**MARTIN LUTHER KING JR. RECREATION CENTER
ROOF REPLACEMENT**

Addendum No. 1

Dated: February 18, 2021

Project No.: 16366E-02-02

5 CURB EXTENSION @ REMOVABLE UNIT
Scale: 3" = 1' - 0"

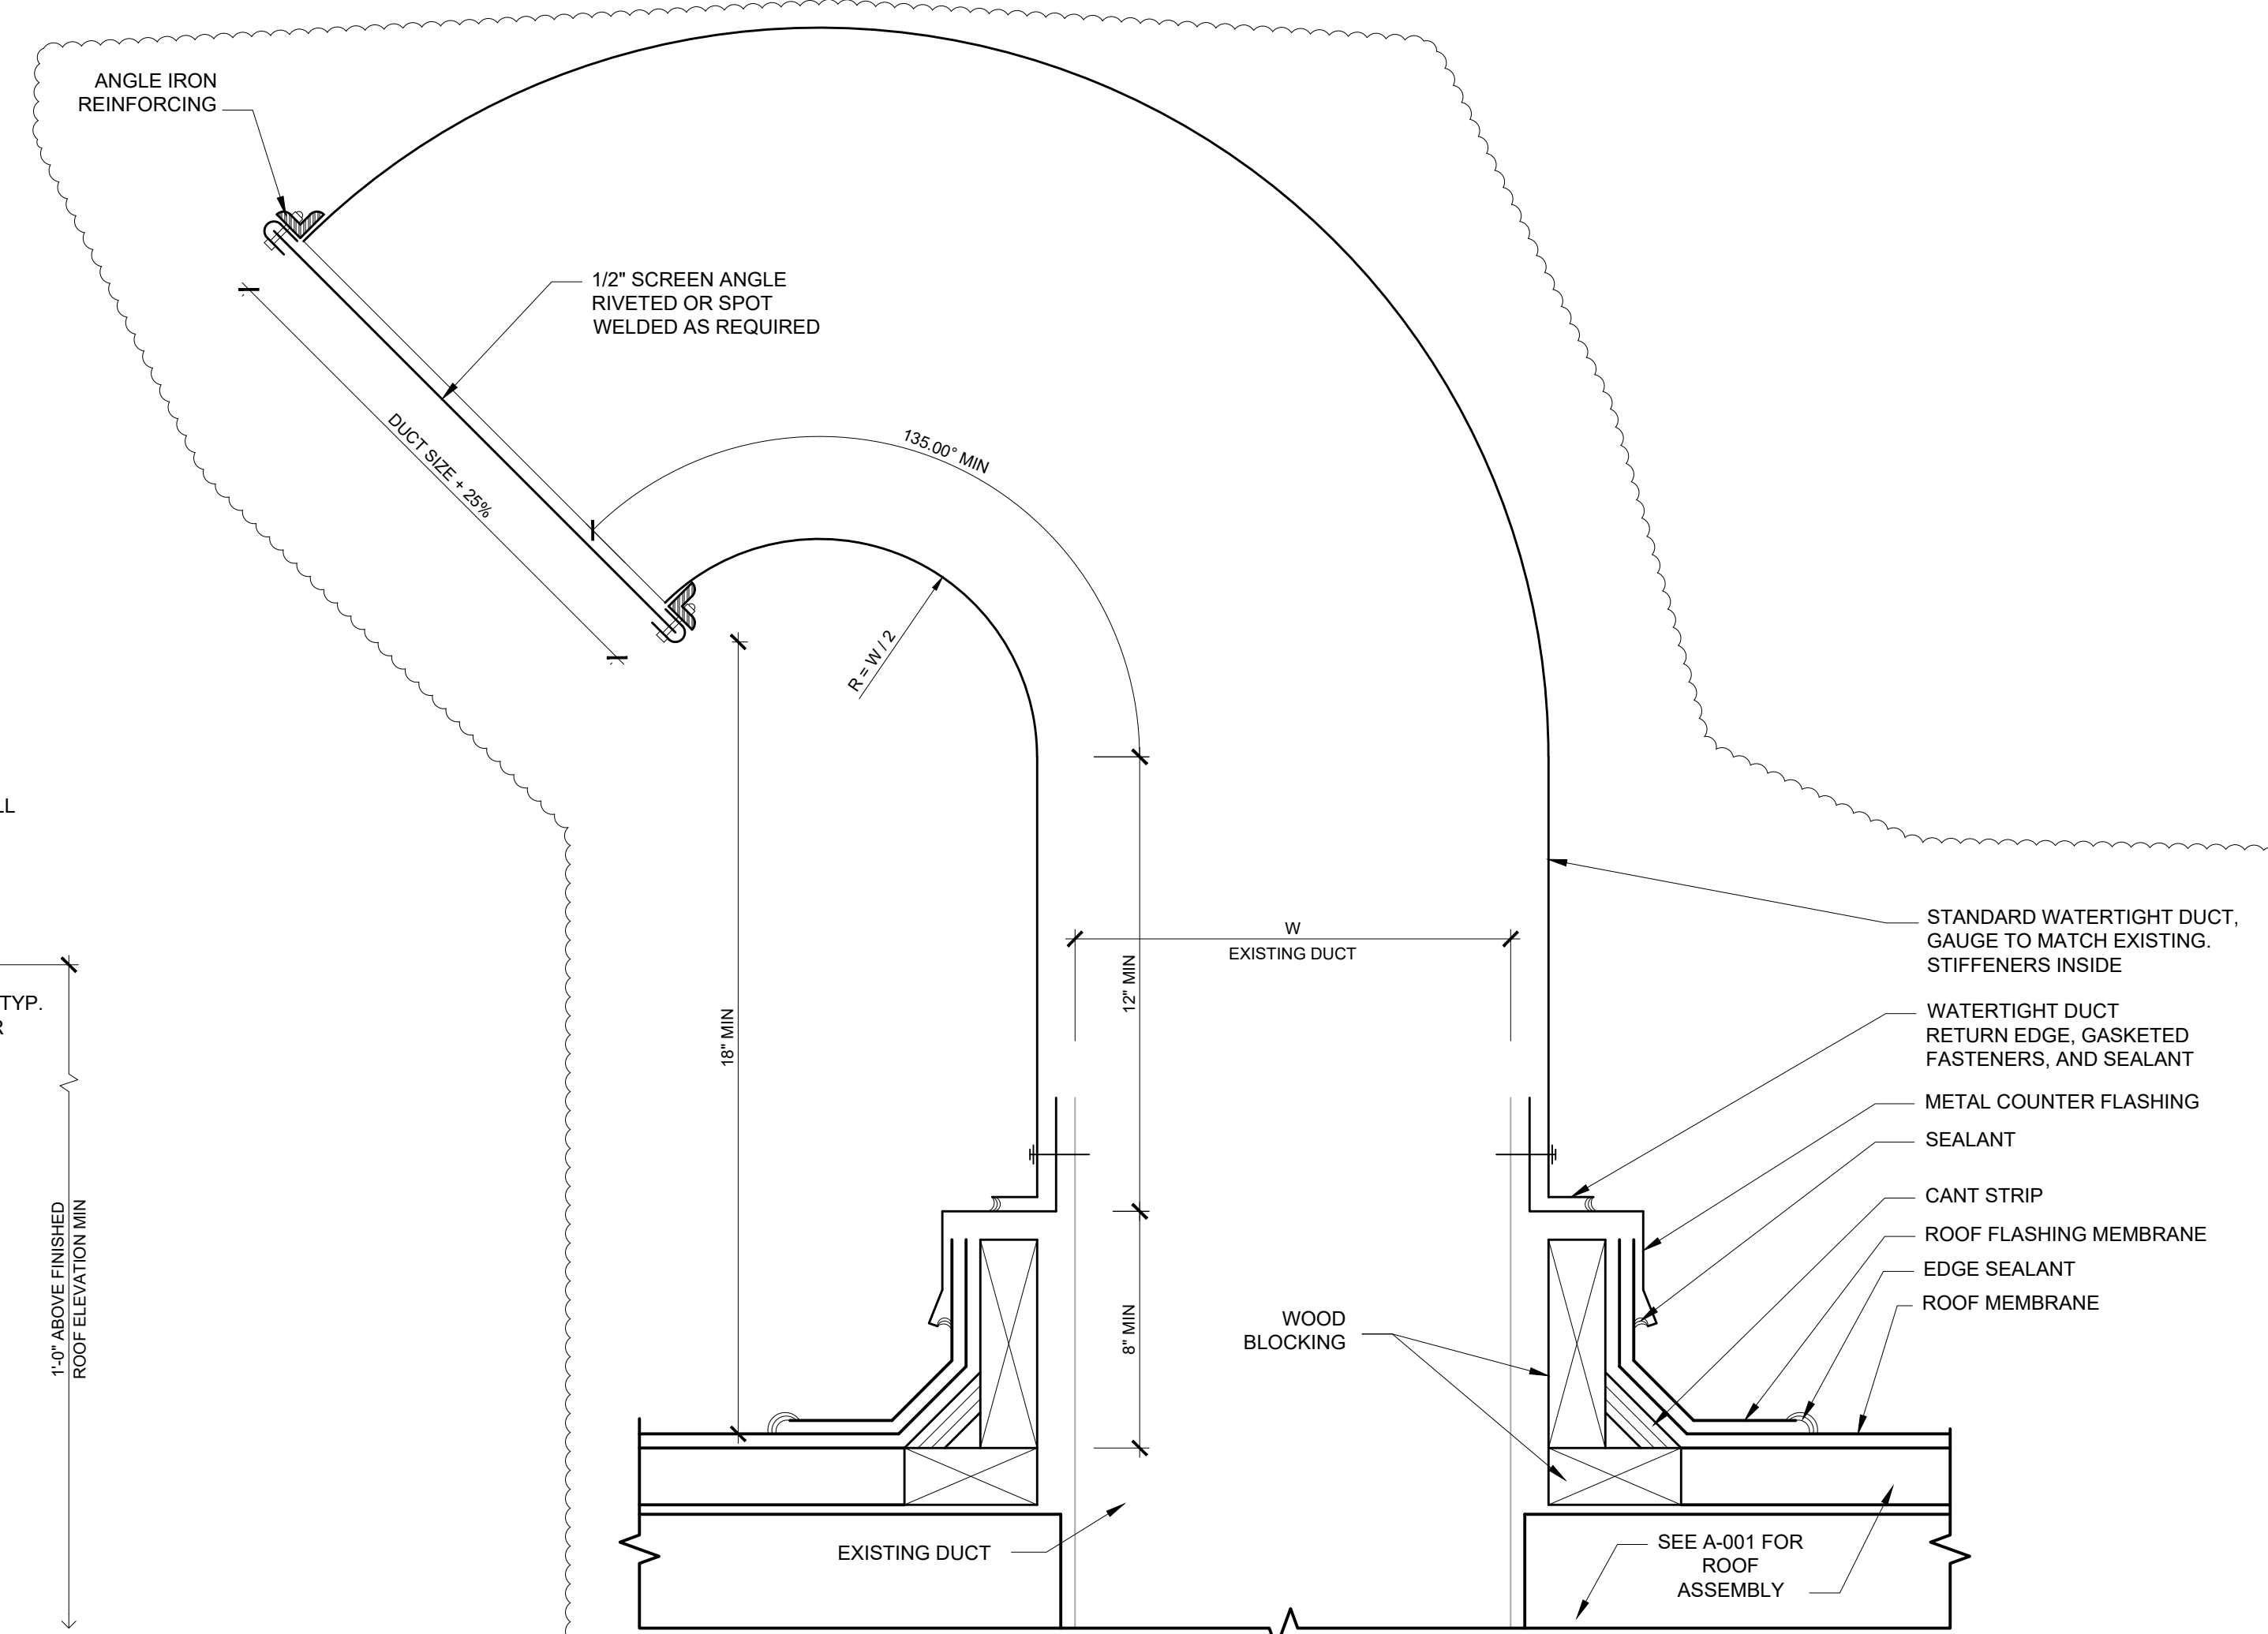
5. Drawing A-500.2:
 - a. Remove drawing A-500.2 from Attachment D – Project Drawings and replace with drawing A-102 that is included in this amendment.

Work No.: **16366E-02-02 CW-1909.02** Drawing No.: **A-001**

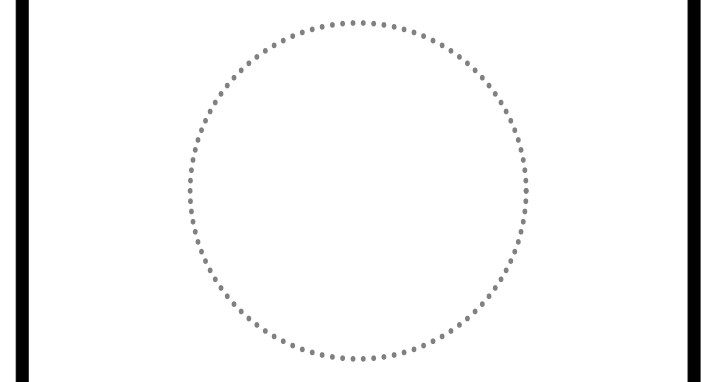
1. Drawing A-001:
 - a. The following clarification applies to Assembly Type 1 at Roof Area 1A, 3C, & 3D: *“THE ROOFING ASSEMBLY AS DETAILED AND DESCRIBED IN ASSEMBLY TYPE 1 AT ROOF AREA 1A, 3C, & 3D GOVERNS OVER THE DETAILS WITHIN THE A-500 SERIES DRAWINGS. EXISTING LIGHTWEIGHT CONCRETE AT ROOF AREA 1A, 3C, & 3D IS TO BE REMOVED IN ITS ENTIRETY DOWN TO THE EXISTING STRUCTURAL DECK. REFER TO DRAWING A-104 FOR PROPOSED TAPERED LAYOUTS, TYP.”*
2. Drawing D-101:
 - a. Remove drawing D-101 from Attachment D – Project Drawings and replace with drawing D-101 that is included in this amendment.
3. Drawing A-101:
 - a. Remove drawing A-101 from Attachment D – Project Drawings and replace with drawing A-101 that is included in this amendment.

1. On the plan on page A-001 On the Assembly Type 1 detail the existing shows there is lightweight concrete and the proposed shows that it is removed. Nowhere else on the plan shows that to be removed. Can you clarify? **Existing Tapered Lightweight Concrete at Roof Area 1A, 3C, & 3D associated with Roof Assembly Type 1 is to be fully removed down to the existing structural deck.**
